MONTGOMERY COUNTY HISTORIC PRESERVATION COMMISSION
STAFF REPORT

Address:	7 E. Melrose Street, Chevy Chase	Meeting Date:	7/14/2021
Resource:	Contributing Resource Chevy Chase Village Historic District	Report Date:	7/7/2021
Applicant:	Debbie Shepherd	Public Notice:	6/30/2021
Review:	Historic Area Work Permit	Tax Credit:	n/a
Case Number:	954009	Staff:	Dan Bruechert
Proposal:	Rear Alterations

The applicant proposes to make several modifications to a rear non-historic addition including:

Figure 1: 7 E. Melrose Street has a non-historic rear addition.

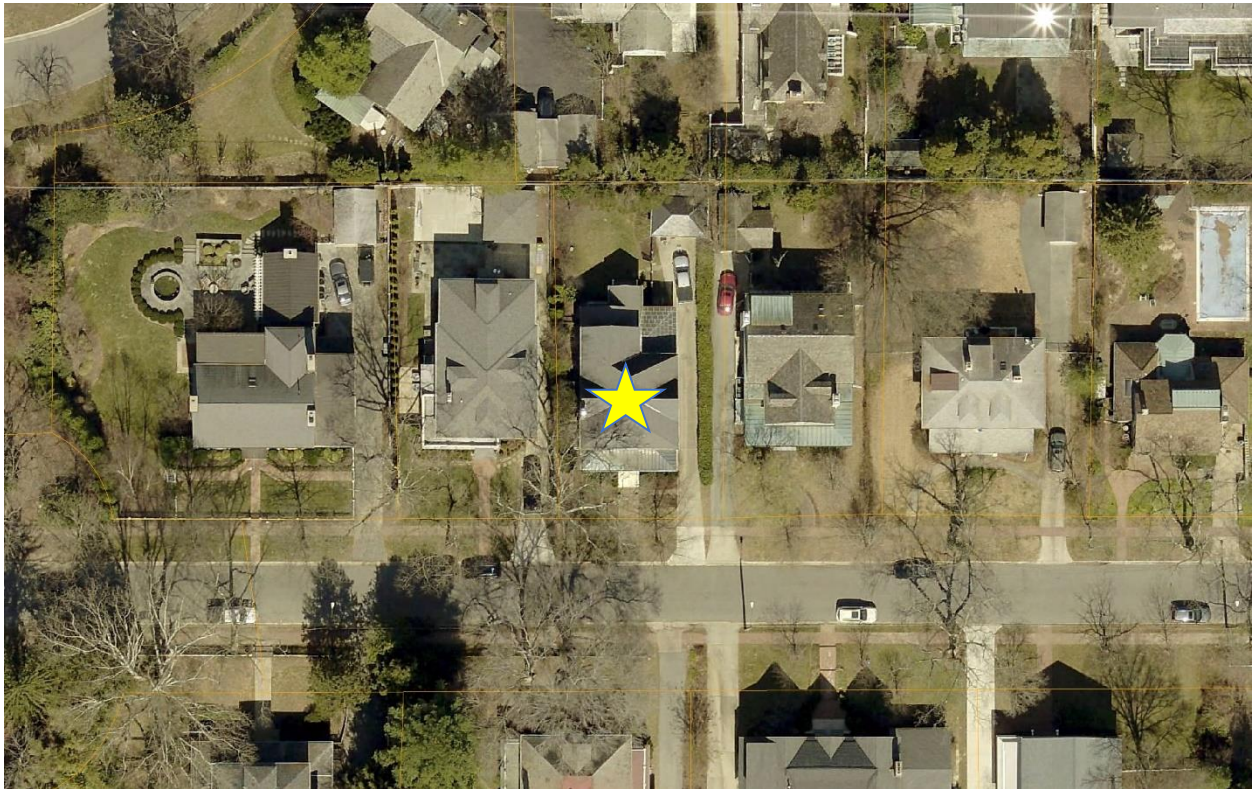
The subject property is a foursquare house with Colonial Revival and Craftsman elements. The original house siding has been covered with vinyl siding. The proposed work under this HAWP involves a number of changes to a non-historic addition at the rear of the historic house. The proposal involves changing the roof form, replacing a number of windows, and constructing a new porch. These changes will not have a substantial impact on the character of the house or surrounding district and Staff recommends the HPC approve the HAWP.

Staff recommends that the HPC **approve** the HAWP.

HAWP - Existing and Proposed Rear View

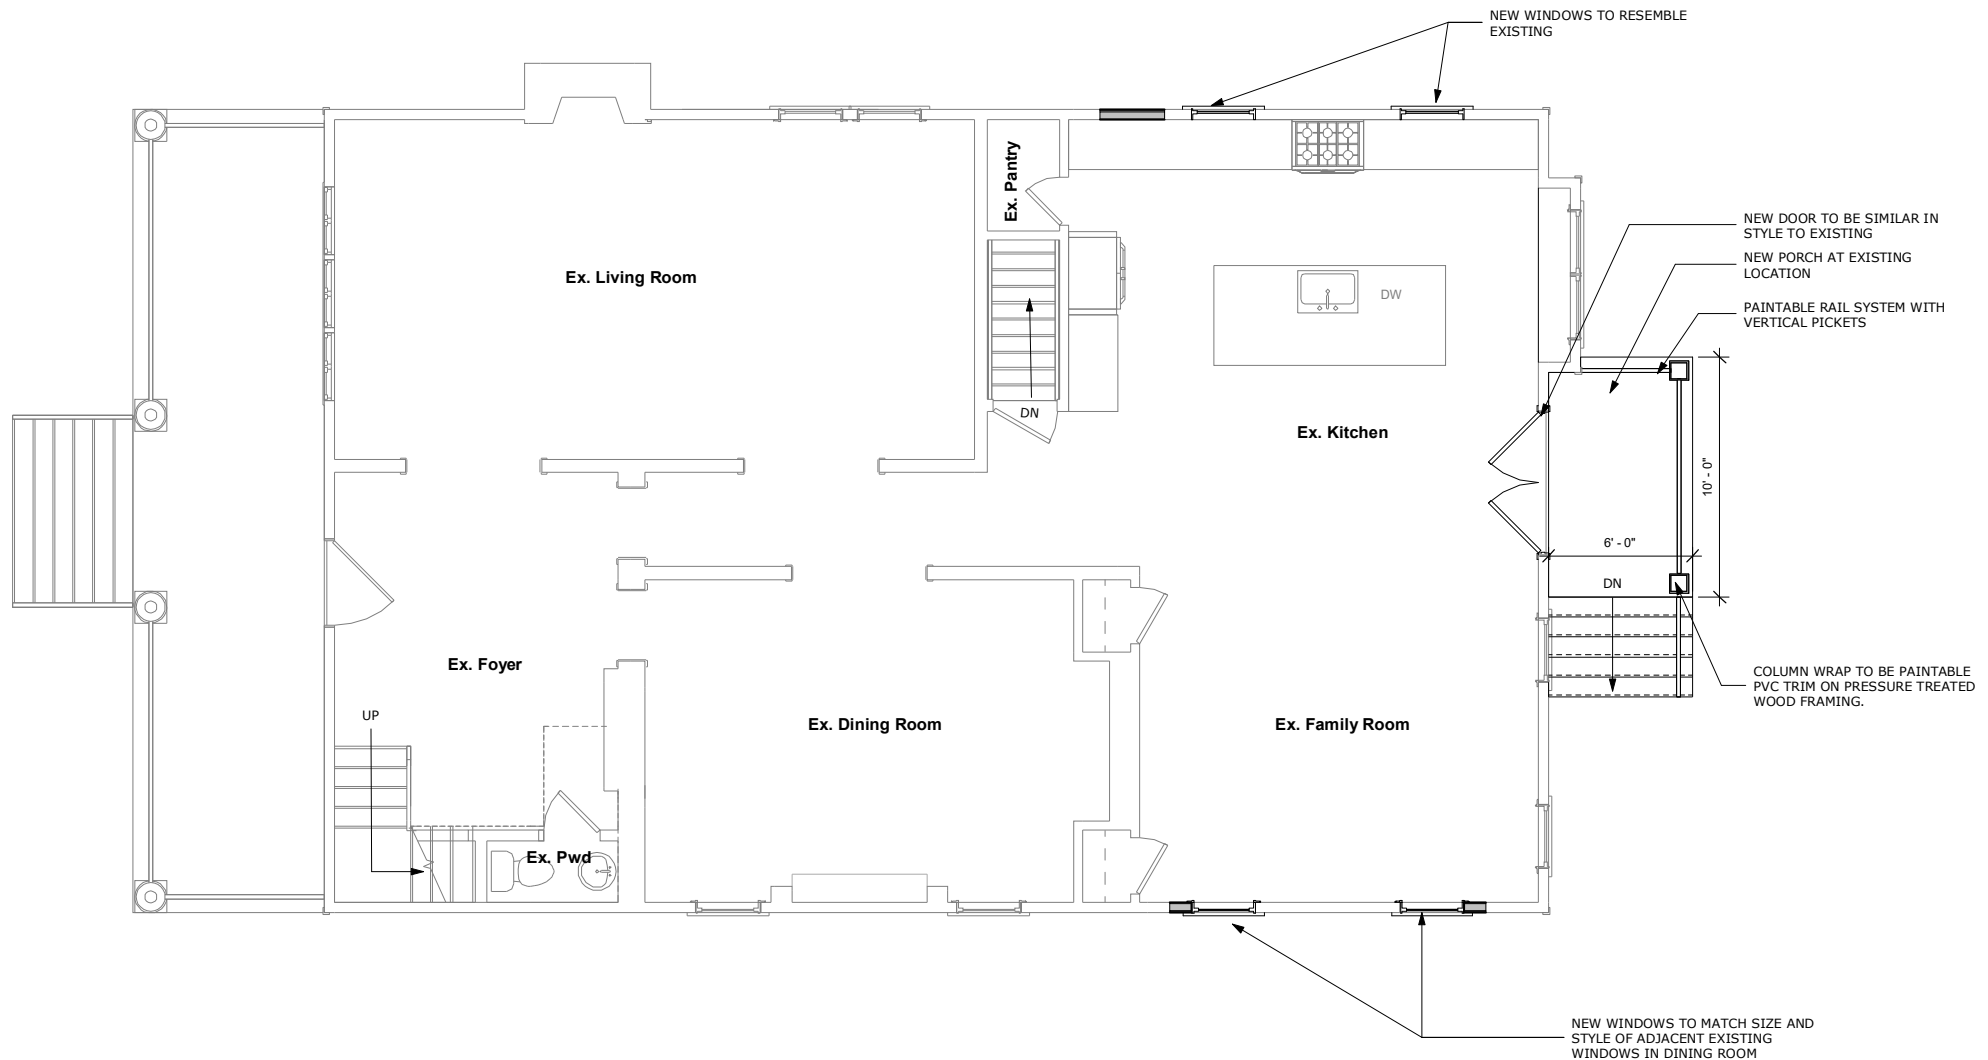
The largest visible change proposed is altering the rear addition's roof form. The existing roof is a rear-facing gable covered in asphalt shingles with a section of a flat roof. The applicant proposes to change this to a low-pitched hipped roof covered in standing seam metal, which will match the treatment and material used in the historic front porch. The proportions of the rear addition will change significantly, however, Staff finds this to be a design improvement. As this change will not be visible from the right-of-way, this alteration should be approved as a matter of course. At the rear, the applicant also proposes to replace the two second-floor sash windows with shorter windows that won't impact the proposed roofline. The proposed windows will match the six-over-one configuration found throughout the house. This window, like all of the proposed windows, will be aluminum-clad wood windows. The last two changes proposed at the rear are related to reconfiguring the rear porch. First, the single, non-historic rear door will be replaced with a pair of aluminum-clad French doors. The second change is replacing and reorienting the stairs. The existing stairs are rear loading, and the applicant proposes to construct a new set of stairs that load from the east (left) side of the porch. The new stairs will be wood and the proposed railing is a paintable rail system.

Staff finds because most of the work is to a non-historic addition, the proposed changes will collectively have little impact on the historic character of the house or the surrounding district. Altering the roofline of the rear addition and porch will not be at all visible from the right of way. The window replacement on the side elevations is to non-historic window openings or to a window opening that is far removed from the right-of-way. Finally, the changes to the porch will only impact a contemporary feature that is not visible from the right-of-way. Staff finds that the one proposed change that shouldn't be approved is a matter of course is patching the siding on the west (left) elevation. Vinyl and aluminum siding are disfavored in Chevy Chase Village, however, Staff finds that requiring the applicant to use a different siding material would visually attract more attention than allowing the applicant to patch the siding in matching vinyl. Staff recommends the HPC approve the proposed changes.
